Date: 13<sup>th</sup> April 2021

**Re: South West Milton Keynes, Updated Transport Assessment**

**Location: Land South Of The A421 West Of Far Bletchley North Of The East West Rail Link And East Of Whaddon Road Newton Longville**

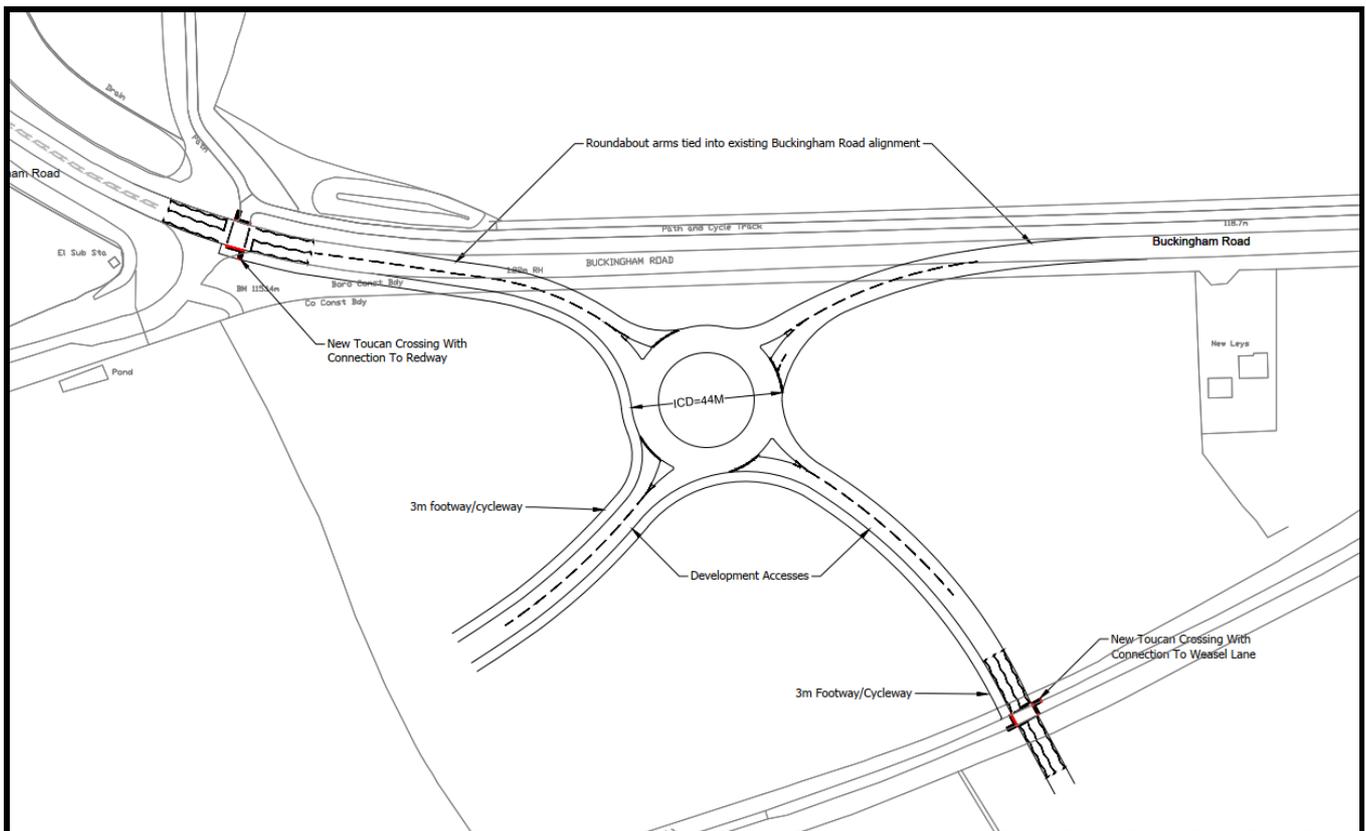
The original Transport Assessment proposed a signalised gyratory arrangement. Both Milton Keynes Council and at the time Buckinghamshire County Council raised concerns regarding introducing traffic signals in this area as well as the complex arrangement, which could be confusing for drivers.

A new four arm roundabout junction has been proposed, encompassing two new site roads. The existing Redway on the northern side of Buckingham Road is to remain and a 3m shared footway is proposed on the southern arms of the junction into the site. Toucan crossings are proposed on the western arm between the new roundabout and Tattenhoe Roundabout and where the new road crosses Weasel Lane, providing safe crossing facilities to the wider pedestrian and cycle network.

During the planning application determination period, and subsequent to agreement of the layout with BC (Buckinghamshire Council) and MKC, revisions were undertaken at the request of BC to provide minor lane marking improvements. These revisions were shown on Drawing 0017D and it is this revision that BC recommend being taken forward.

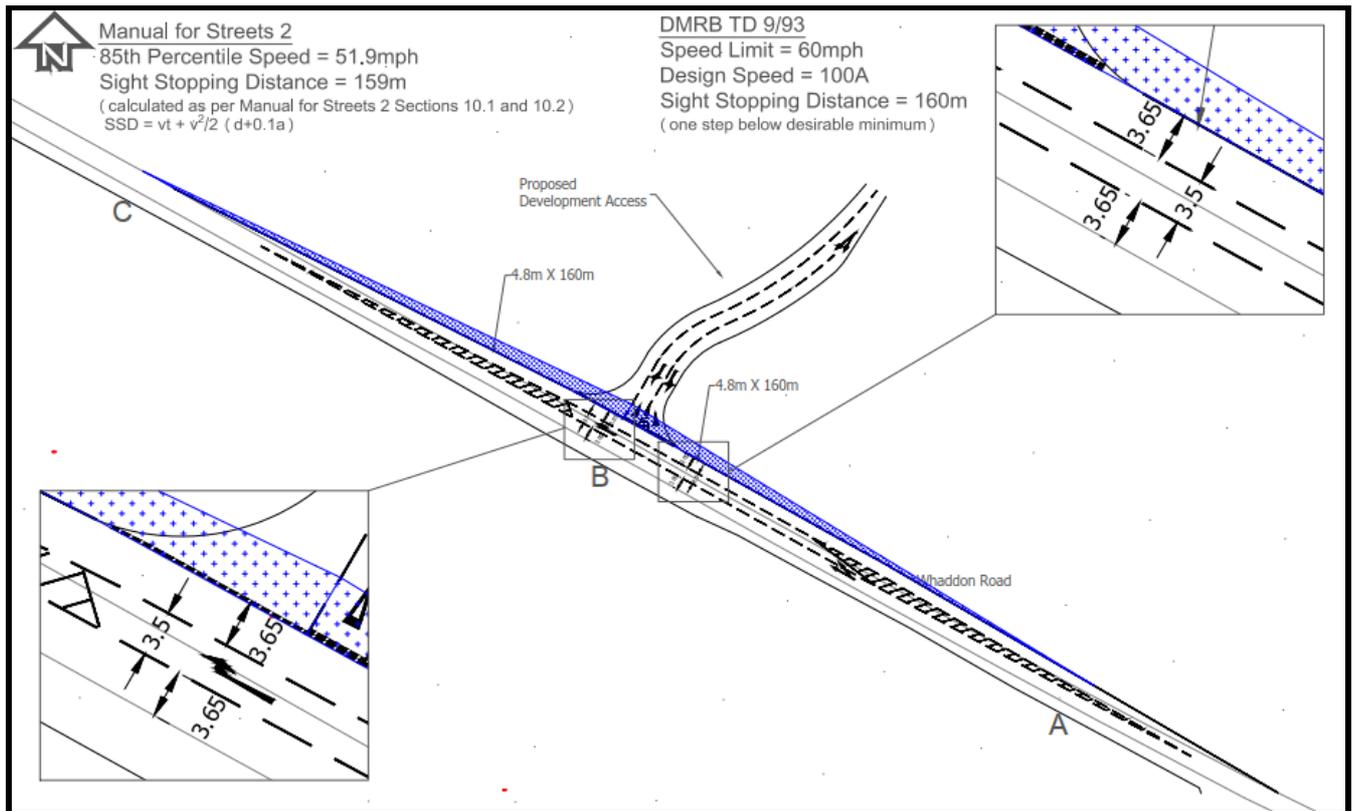
An independent Stage 1 Road Safety Audit has been undertaken and Buckinghamshire Council is satisfied that the problems identified can be resolved during detailed design. The current design as shown in the May 2020 TA shows wide single lane entry approaches on Buckingham Road East, Buckingham Road West and the eastern Site Access. For these arms of the roundabout to work effectively, as modelled, they should be widened to two lane approaches capable of accommodating 2-3 cars. Furthermore, to improve circulation of the roundabout the diameter of the central island should be reduced. This is achievable within the limits of the highway and land within the applicant's control and can be secured by way of a condition revisions were undertaken at the request of BC to provide

minor lane marking improvements, as shown on Drawing 0017D. This version would be required to be taken forward to detailed design.

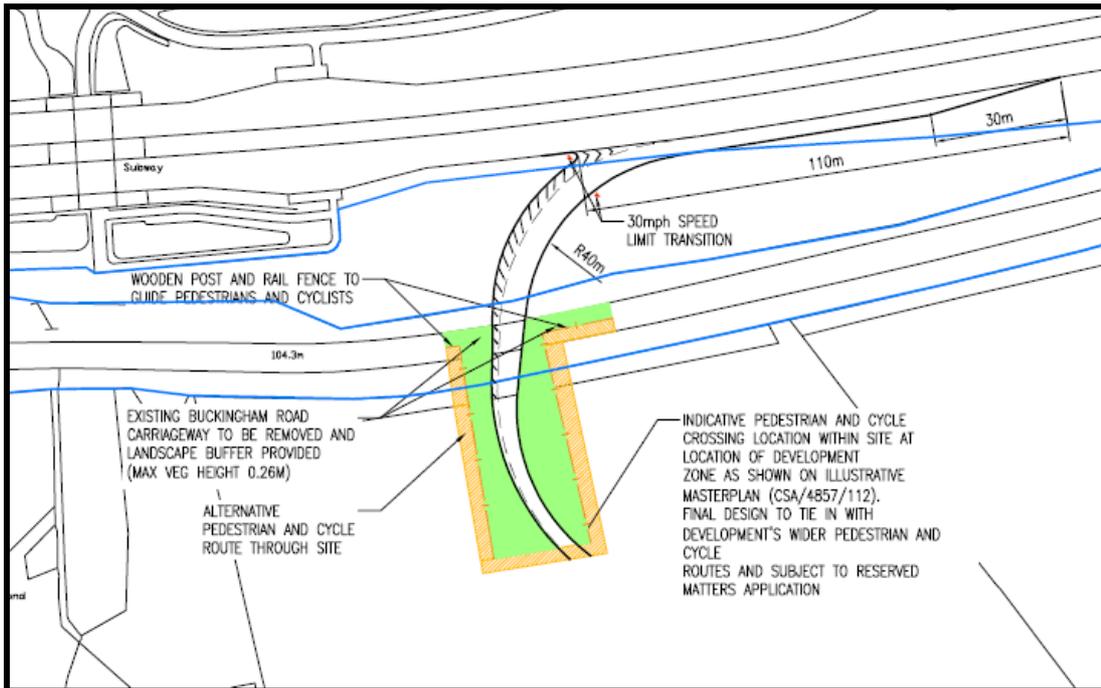
The design of the access from A421 Standing Way is in the form of a left in only junction and falls within Milton Keynes Council's jurisdiction. It should however be noted that Buckinghamshire Council does not have any objections in principle to the proposed access arrangement, noting that the junction has been designed in accordance with relevant design standards. Buckinghamshire Council did raise concern over how the access will interact with the Old Buckingham Road alignment, which is used by pedestrian and cyclists, and potentially the same user groups from the development will also make use of the route. It was considered that measures would be needed to ensure safe crossing movements for non-motorised user with potential high vehicle speeds (relative) on exiting the bend of the new access and restricted intervisibility.

In TRN1 the applicant provided an arrangement to manage the potential interaction with Old Buckingham Road, replicated below. The arrangement would enable pedestrians and cyclists to divert further into the Site and to cross the proposed road access safely. Whilst this design provides a less direct route, it does in principle provide a safer crossing location with lower vehicle speeds. The set-back crossing also reduces the potential environmental impact of tree removal to ensure adequate intervisibility for an in-line crossing, the design of which would be finalised as part of reversed matters.

Based on the new information provided, Buckinghamshire Council does not have any objections in principle to the proposed access arrangement, subject to detailed design and entering into relevant Highways Agreements. This can be secured via means of a S106 obligation.

**Junction 3: Bletchley Road/Stoke Road/Drayton Road/Whaddon Road – Mitigation proposal**

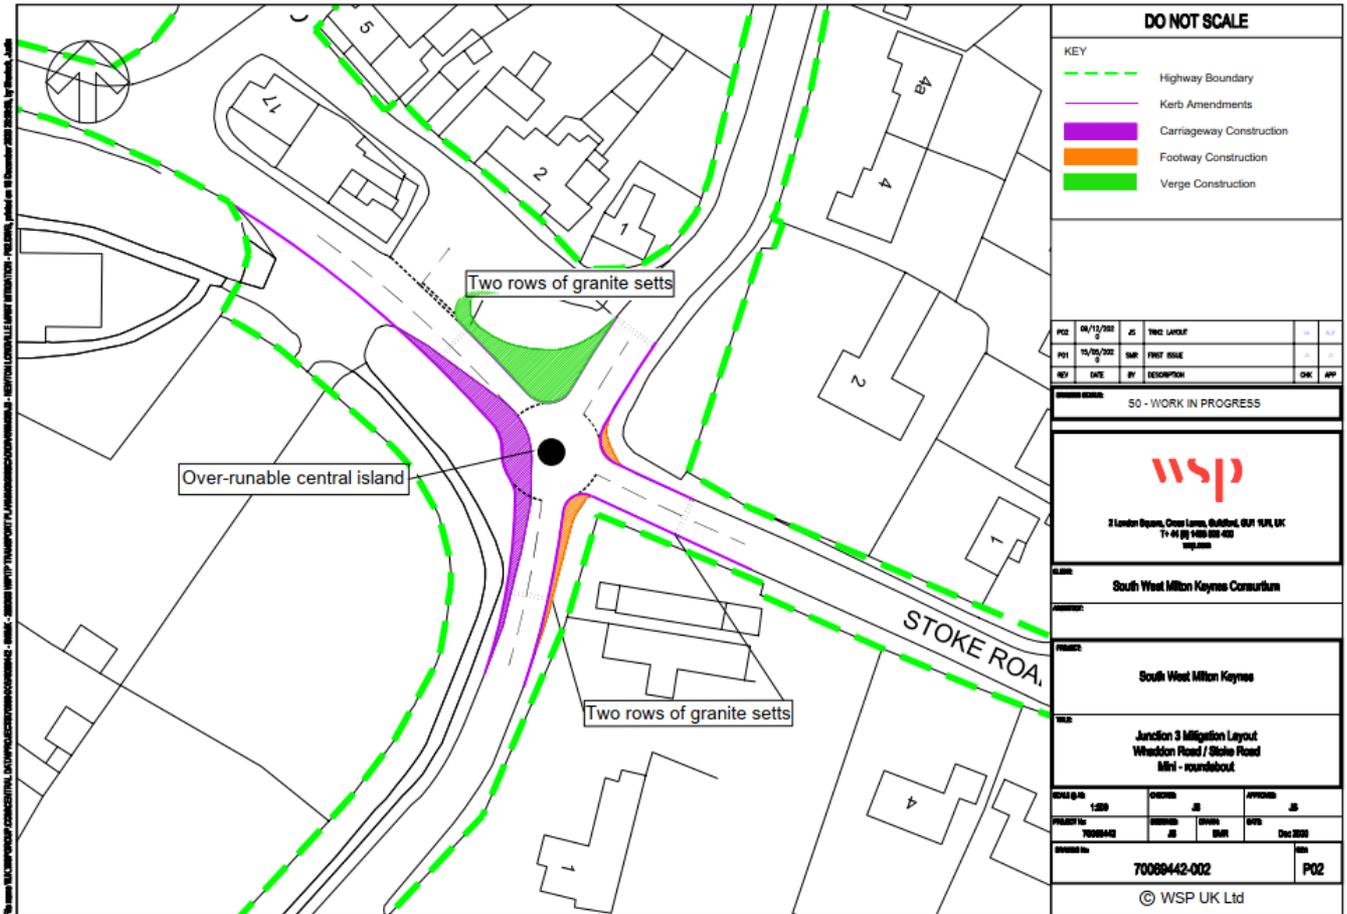
The modelling exercise has shown that the addition of development traffic would have a material impact on the operation of the junction. The Applicant has however proposed changing the form of the junction from a priority crossroads to a mini roundabout, shown below.

The mitigation scheme results indicate the mini-roundabout would operate within practical capacity (RFC of 0.85) for all DS scenarios with a maximum queue of 3 vehicles and delay 20 seconds on Stoke Road. Whilst the change in junction form would improve the capacity, operational road safety concerns were raised within the Road Safety Audit in relation to operation, lack of deflection (due to land constraints) and achievable visibility due to adjacent property lines. Initial indications on review of the mini-roundabout design against 'CD116 Geometric design of roundabouts' showed less than desirable visibility to the right on Drayton Road and stopping sight distance on three of the arms. Paragraph 2.12.1 of CD116 also states that a 4-arm mini-roundabout should not be used where the sum of the

On this basis, the Highway Authority recommends that the junction is retained as a priority crossroads. A new raised junction table should be provided, as part of a comprehensive traffic calming scheme for Newton Longville. This would act to slow vehicle approach speeds to the junction and make the junction more visible to drivers. The cost of providing a raised table in this location has been included in the proposed traffic calming contribution, set out later in this response.

**Junction 7: A421/Coddimoor Lane/Whaddon Road – Mitigation proposal**

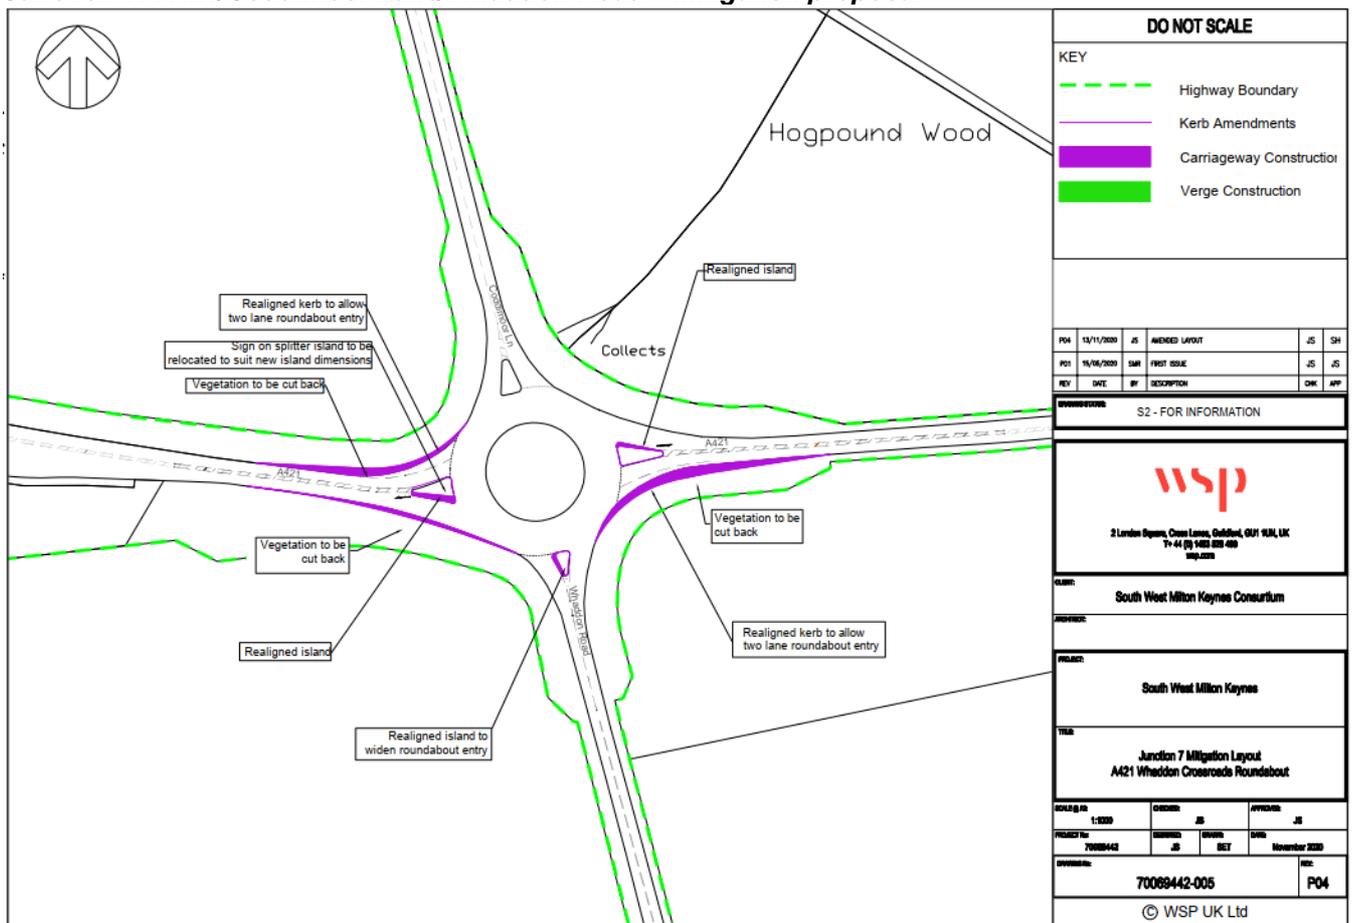
The Applicant has proposed alterations to the current layout to improve capacity, this involves realignment of the kerbs on the approaches from the A421 (east) and A421 (west) with associated amendments to the kerb/islands allowing for two lane roundabout entry and short two lane exit. Whaddon Road entry would also be widened with a reduction in the traffic island size. Due to the minor kerb line amended the previously determined capacity corrections were maintained.

The proposed improvement to this junction should provide a 'nil-detriment' situation, whereby the highway network is 'no worse off' with the proposed development in a future forecast year of 2033. This goes beyond the requirements of the NPPF and therefore is considered acceptable by the Highway Authority. This improvement can be delivered by S278 highways agreement, which is to be secured by way of a S106 obligation.

**Junction 8: A421/Warren Road – Mitigation proposal**

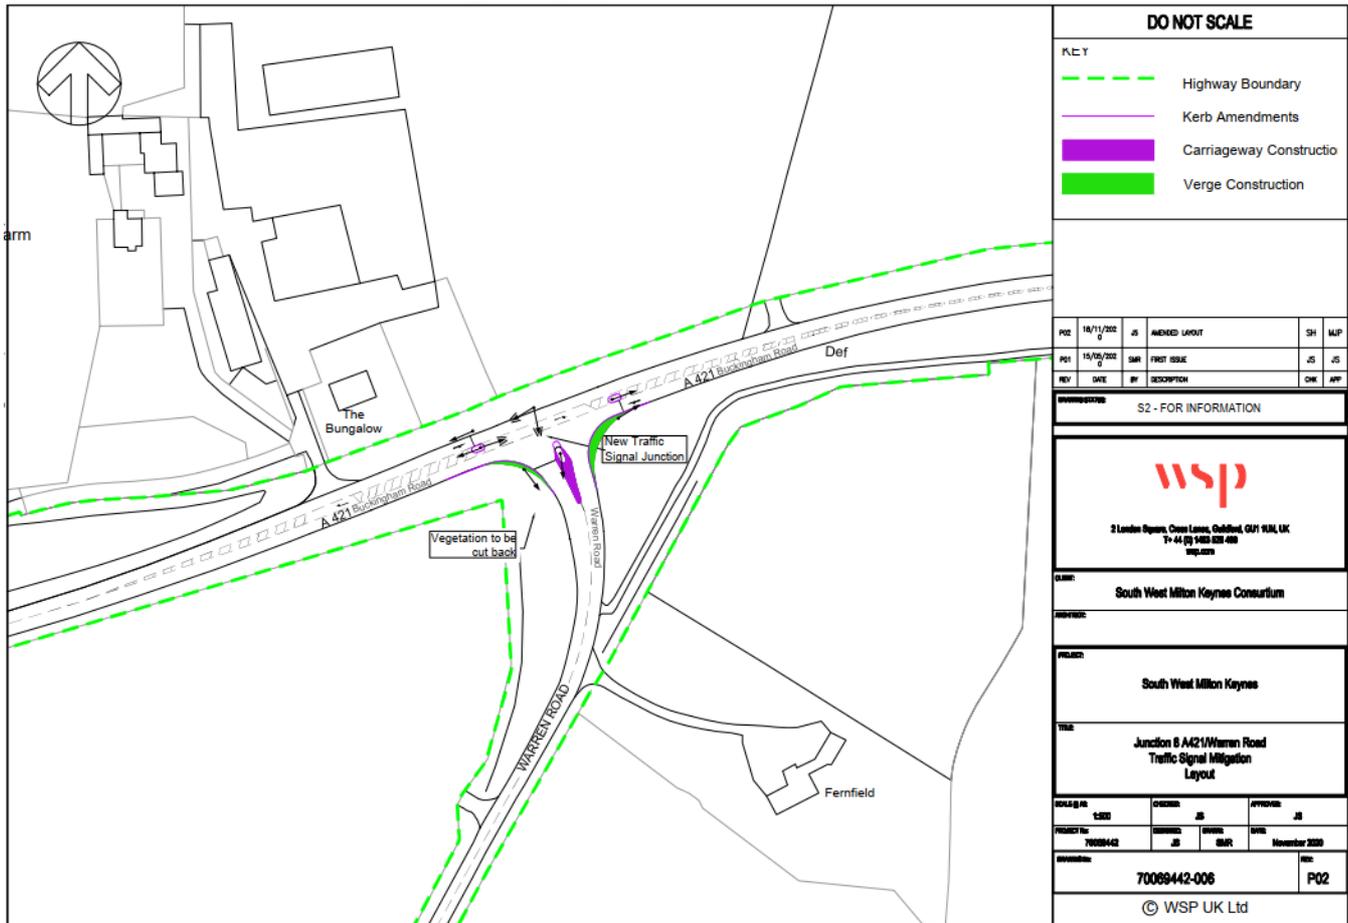
The development is only likely to result in a marginal increase in queuing and delay on Warren Road. In reality drivers would look for alternative routes to the A421. The static junction model does not consider re-assignment of traffic, which would be likely to take place. Whilst the development only results in a marginal increase in queuing at this junction, the applicant has proposed a mitigation scheme to increase capacity through signalisation of the junction.

The proposed improvement to the A421/ Warren Road junction has been modelled using LinSig3 and the results indicate significant benefits in terms of queuing and delay on Warren Road in all the modelled scenarios, with the DS3 (including both SWMK and projected Shenley Park development traffic) have predicted queues and delay less than current 2020 results. However, the signalisation of the junction would impose queues and delay on the A421 corridor.

**Junction 9: A421/Shucklow Hill/Little Horwood Road – Mitigation proposal**

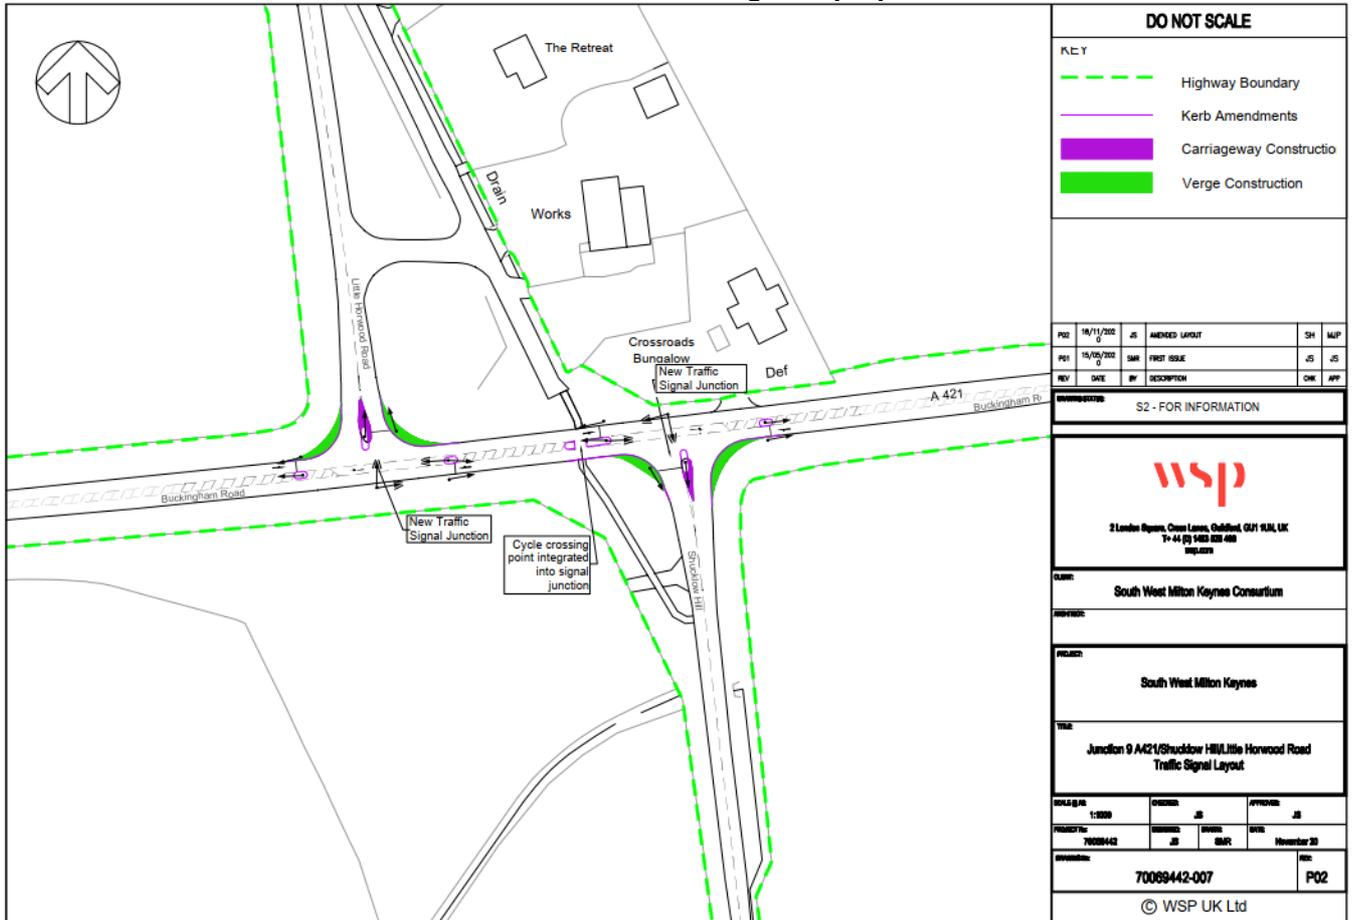
The development is only likely to result in a marginal increase in queuing and delay on Shucklow Hill/Little Horwood Road. Due to the likely capacity restriction on the minor road's drivers would in reality look for alternative routes to the A421. The static junction model does not consider re-assignment of traffic, which would be likely to take place. Despite this, the Applicant has proposed a mitigation scheme to increase capacity through signalisation of the junction.

The proposed improvement to the A421/ Warren Road junction has been modelled using LinSig3 and the results indicate significant benefits in terms of queueing and delay on Shucklow Hill and Little Horwood Road in all the modelled scenarios. However, the signalisation of the junction would impose queues and delay on the A421 corridor with a queue of 24 predicted for the western arm of the Little Horwood side of the staggered crossroads.
